Flight Procedures Cover Page	Task Action: FLIGHT CHECK	Task Type: IAP	Estimated Chart Date: 03/19/2026	APWS Task ID: 864F32162F6C4E6584C5AFB568F33510	APWS Project ID: 00C896C3A8AF44F6BC889E6278105E1A
Procedure: RNAV (GPS) Y RWY 17L AMDT 2		Enroute: NO	Specialist: Hirst, Charles		Agreement Number:
Airport ID: KDEN			Airport City: DENVER		State: CO
Facility ID:	Facility Type:	Flight Inspection Remark Type: New FC Slot

ADD INITIAL FIX GOLFN. REDESIGN MISSED APPROACH.

Denver, CO
Denver International, KDEN
RNAV (GPS) Y RWY 17L

AUTOMATED AL-9077 RNAV (GPS) Y RWY 17L

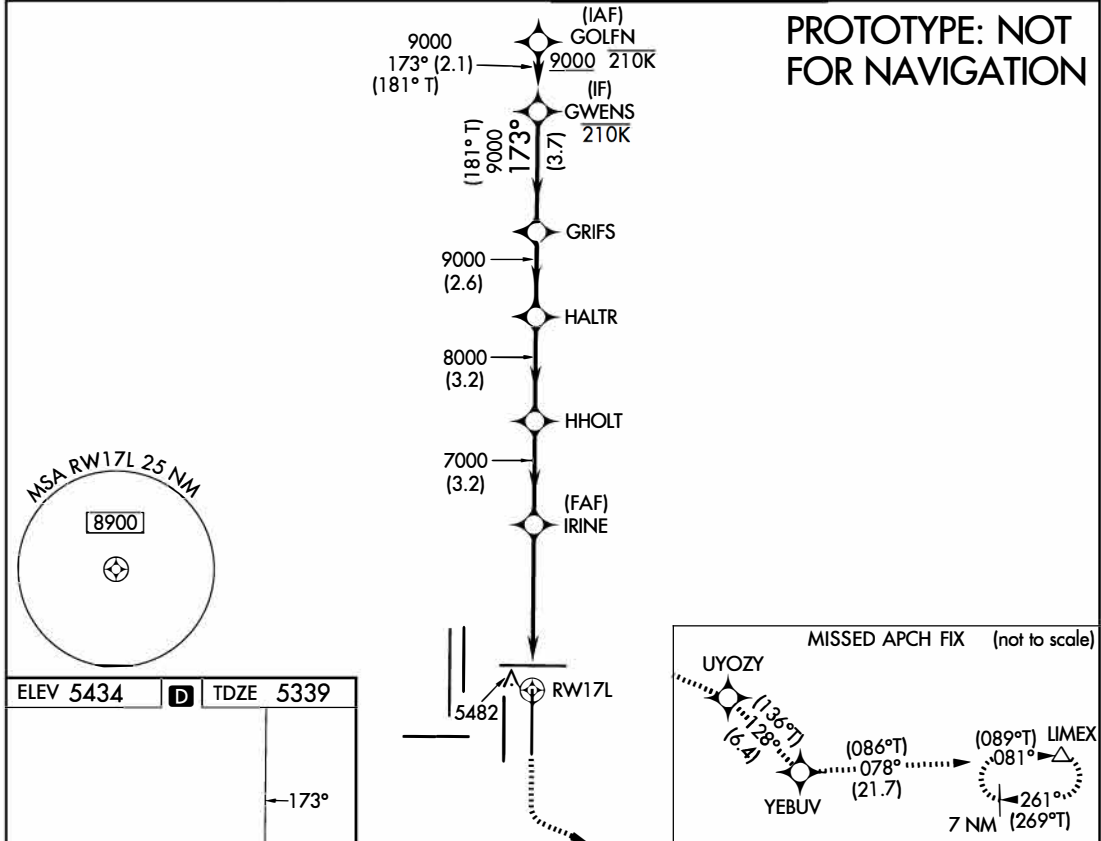
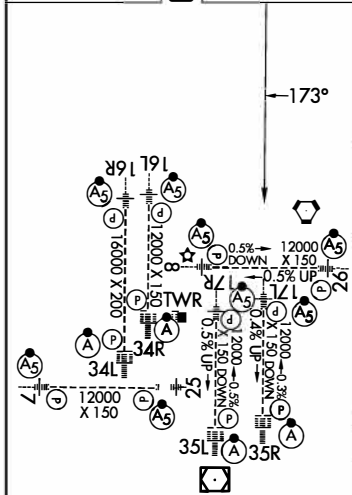
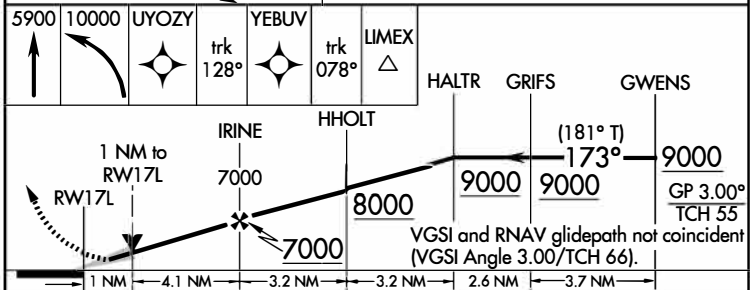
- NOTES ADDED "CHART SPEED ICON IN PLANVIEW AT GWENS: MAX 210 KIAS"
- NOTES CHANGED FROM "CHART NOTE: USE OF FD OR AP PROVIDING RNAV TRACK GUIDANCE REQUIRED DURING SIMULTANEOUS OPERATIONS" TO "CHART NOTE: USE OF FD OR AP REQUIRED DURING SIMULTANEOUS OPERATIONS"

MISSED APPROACH: CLIMB TO 5900, THEN CLIMBING LEFT TURN TO 10000 DIRECT UYOZY AND TRACK 128.07 TO YEBUV AND TRACK 078.42 TO LIMEX AND HOLD.

AL-9077 (FAA)

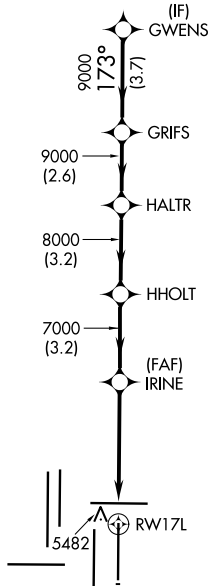
MALSRL 	MISSED APPROACH: Climb to 5900 then climbing left turn to 10000 direct LIMEX and hold.
--	--
